Visual Knitwears Limited (9466)

21.MAY.2014

Identified Priority 1 Concerns

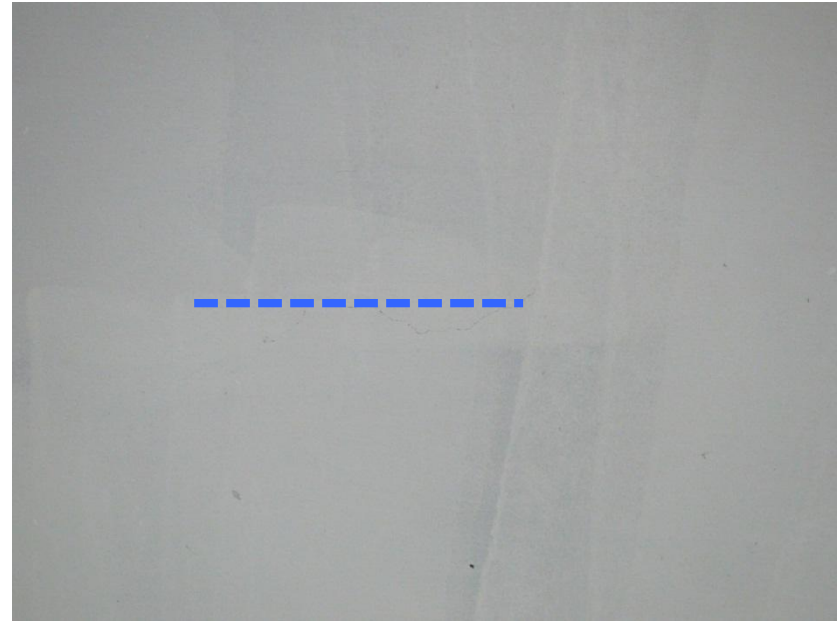
Some of steel joist beam supported steel checkered plate are sagging. Main steel beam connected to steel column are used to transfer the load carrying onto ground slab. Capacity check should be carried out.
